Periyar Project; Approving with remarks the statement showing the distribution by departmental heads of the amount which can be spent during the current year, on the —.

Irrigation.

From Major W. L. C. BADDELEY, R.E., Superintending Engineer, II Circle, to the Chief Engineer for Irrigation, dated Bezwada, 13th August 1896, No. 1244 K.

Reports on the
damages done
by the floods in
the Krishna in
August 1896.

KISTNA RIVER SHOWING ANCUT & RAILWAY BRIDGE

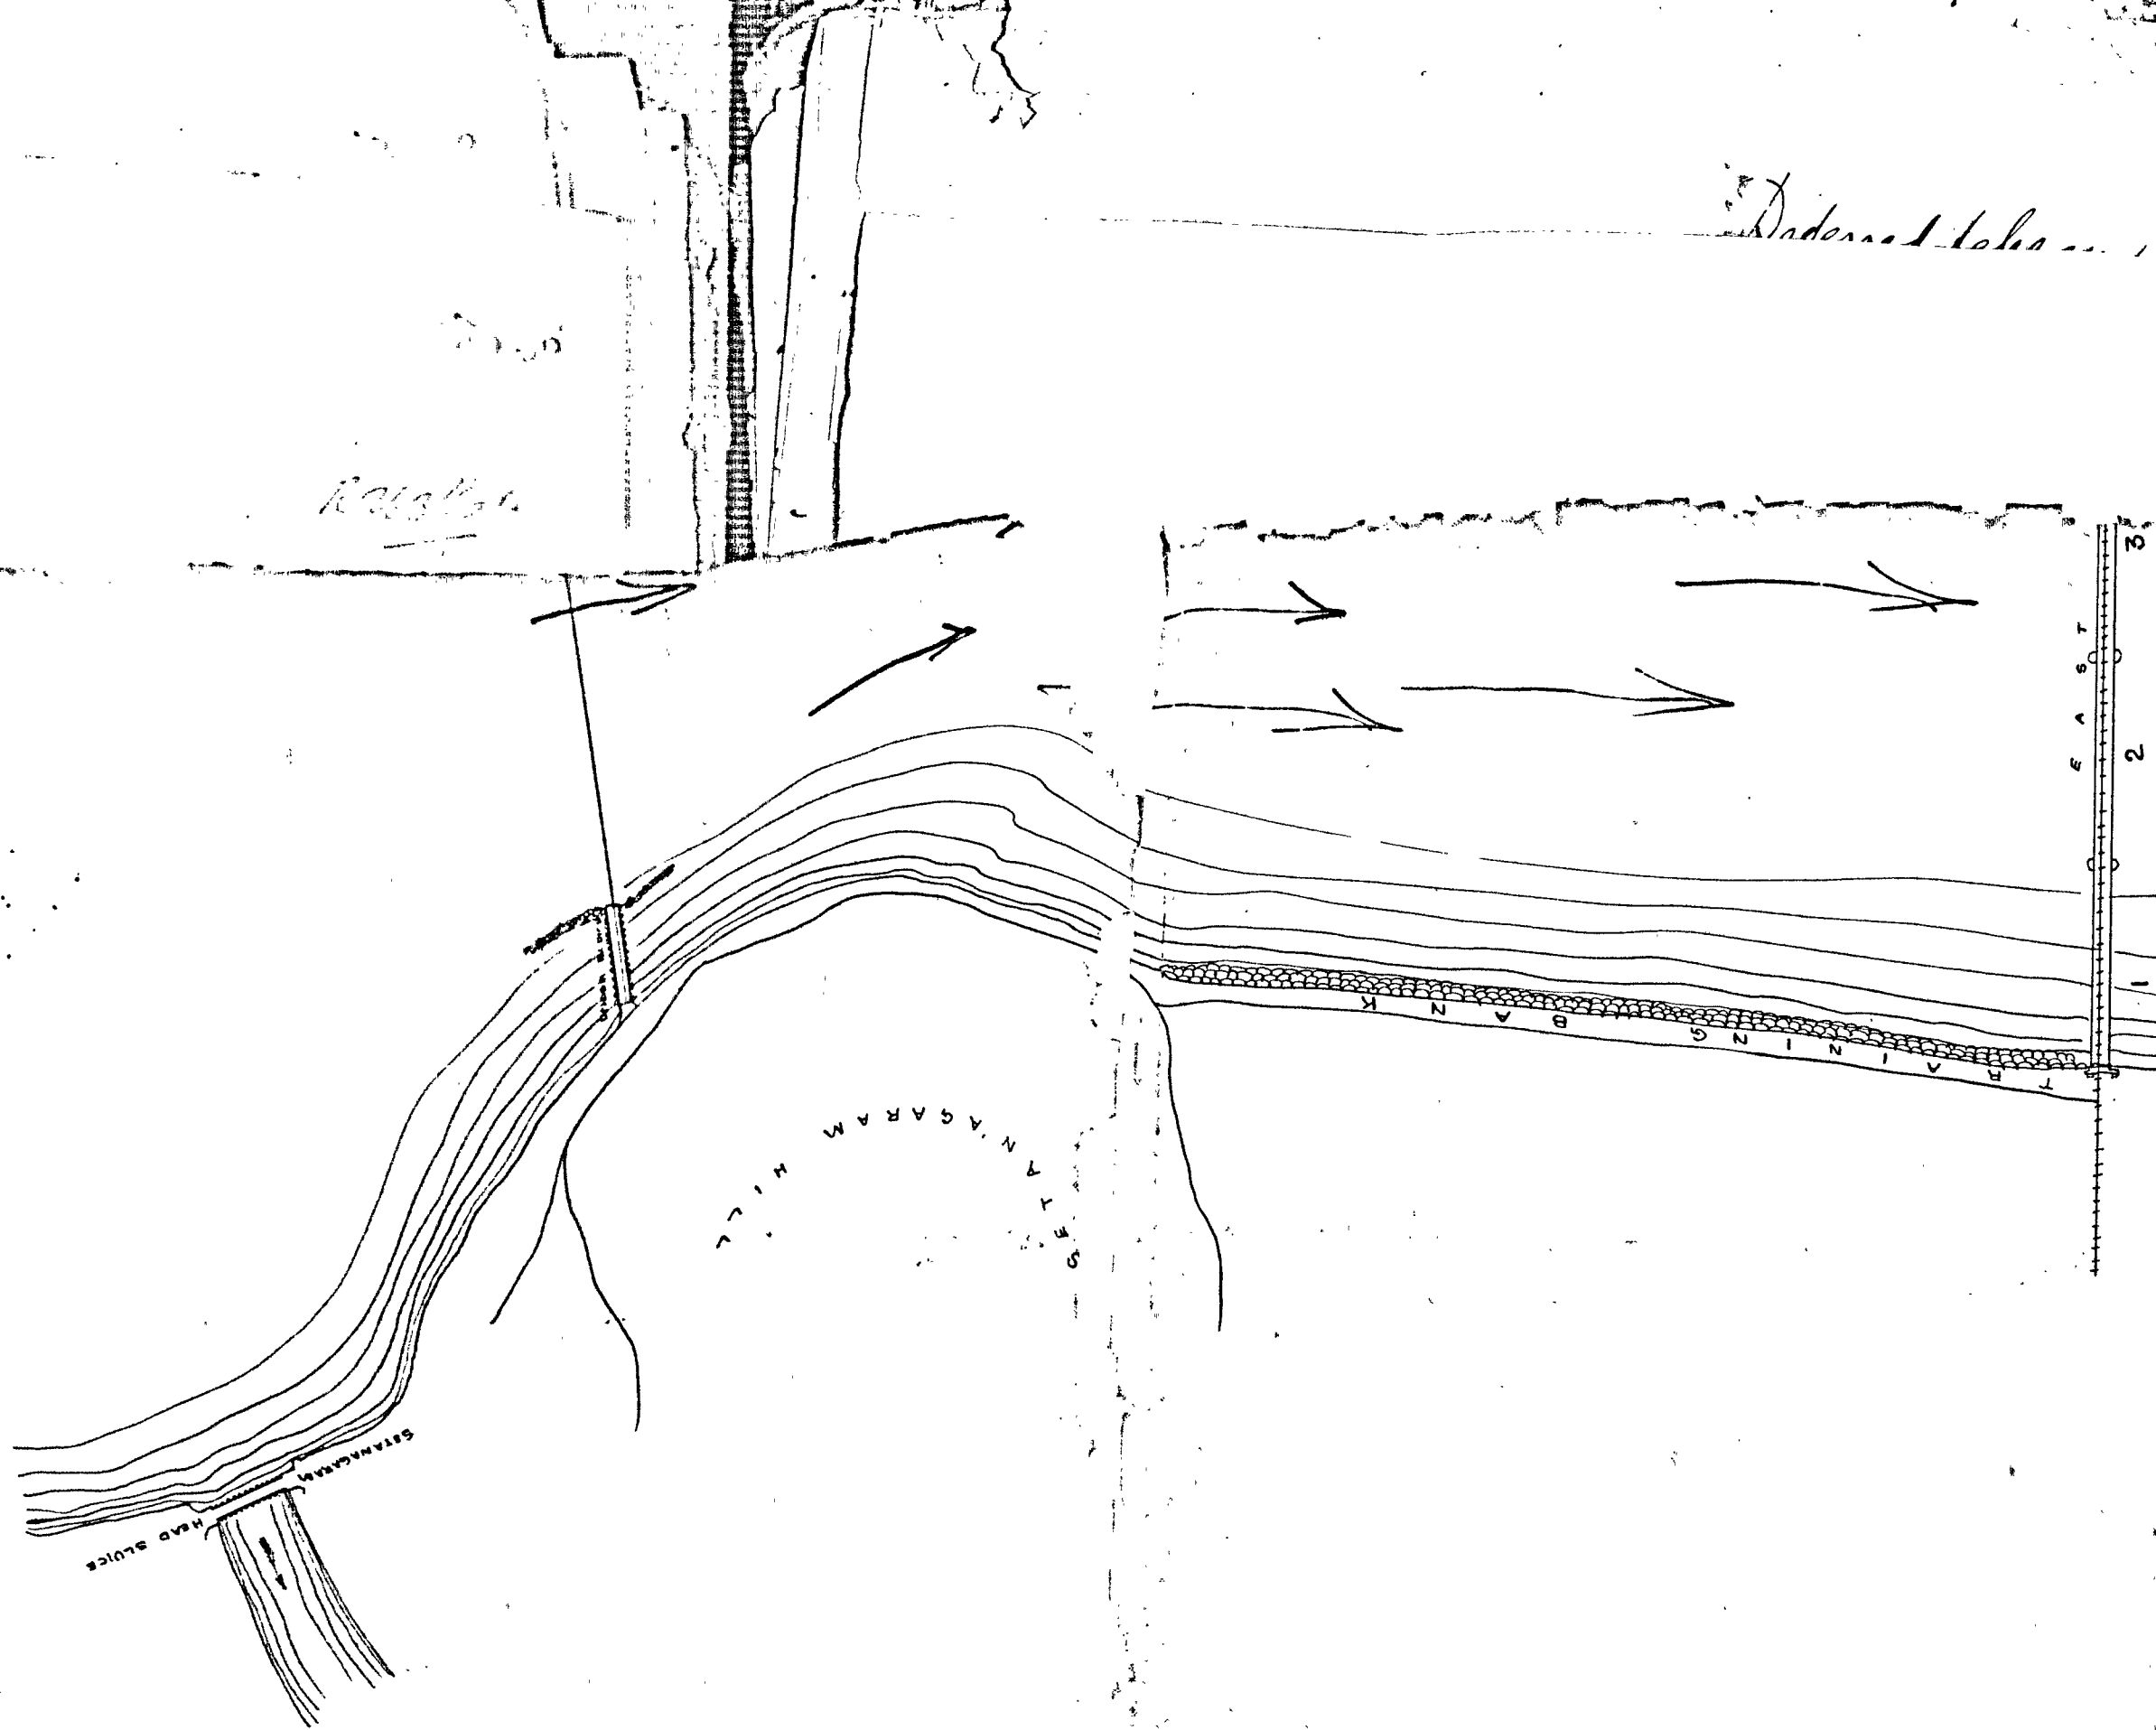
8. I now come to a question which requires much consideration. The effect of the Railway bridge is to contract the water way, as can be seen from the Survey, and unless the bridge is lengthened by 3 spans of 300' on the Eastern side, I fear that the Ament will some day be breached near the Bezwaada under sluices. The fall in the level of the river is revealing signs of damage to the Ament on the Bezwaada side, but we cannot find out anything for certain for some months.

9. The Survey I attach to this letter shows how very much the river has been contracted by the bridge and North training bank, and when it is considered that the bulk of the water passes through the nine spans commencing from the Northern side, the reason for the heavy scouring action that now is going on, below the apron, near the Bezwaada under sluices, is not far to seek. The bridge has 12 spans, the spans 1, 2, 3, commencing from the right bank do comparatively little work. 4, 5, 6, 7 and 8, pass the bulk of the water. 9, 10, 11, and 12, do more than 1, 2, & 3, but much less than the centre spans. 10. It is an axiom for the proper situation of an Ament that there shall be the first possible escape for the water in rear

near, but what is the case at Beywada?
The original spread of the river has been
throttled by the bridge and training bank,
and during the flood, the velocity of
the water passing through the centre spans
of the bridge was so great that, looking
down upon it from the bridge, the effect
was not that of water passing ~~under~~
rapidly ^{under} a bridge but more like the effect
observed when water is discharged
through an undersluice.

The effect of this contraction is to produce
back currents and whirlpools, which
last year scoured out a hole 50 ft deep
in the place referred to, and this scour
hole will have increased this year,
for, during the flood, the back currents
and disturbance near the undersluices
were most marked.

12. It appears to me from an examina-
tion of the Survey that the water passing
over the Aicut which is 3700 ft. across
length during floods, passes into a
basin which is contracted at its mouth
by the fact that the centre spans of
the bridge pass the bulk of the water.
How far this tends to raise the level
of the water above the Aicut I cannot
say, but about the back currents & distur-
bance and consequent danger it causes
to the Aicut, there is not a shadow of a
doubt in my mind. I may remark that
this is no new theory of mine. I have con-
sidered the protection bund a danger
to the Aicut ever since I have been
in charge of the Cutch, and the state of
the ruin below the Aicut on the Beywada
side, during the flood, was such as to
convince me that the interests of the
aicut demand a freer escape of water
in rear of it. The matter, in my opinion,
is one that must be decided chiefly
from the point of view of the responsible

DURING THE FLOODS IN AUGUST 1896
 SPANS NO 1, 2, 3 PASSED VERY LITTLE WATER
 SPANS 5, 6, 7, 8 PASSING MOST OF THE WATER
 SPANS NO 9, 10, 11 & 12
 PASSED MORE THAN 1/2 AS MUCH AS
 SPANS 5, 6, 7, 8. THE SET OF THE RIVER
 ABOVE THE ANICUT WAS AT A RIGHT
 ANGLE TO THE ANICUT AND NOT AS
 BEFORE TOWARDS SEETANAGARAM.

3. As regards the effect the railway bridge has had, and apparently will continue to have, in imperilling the safety of the anicut and head works and the whole of the Kistna delta system, the undersigned is in concord with the Superintending Engineer's views. The Government of India, the undersigned has been informed by the Consulting Engineer for Railways, has ordered Mr. Upcott, who arrived in Bombay yesterday, to proceed direct to Bezvada and consider this question, together with the Superintending Engineer and the Agent of the East Coast Railway. Their conjoint report may be awaited.
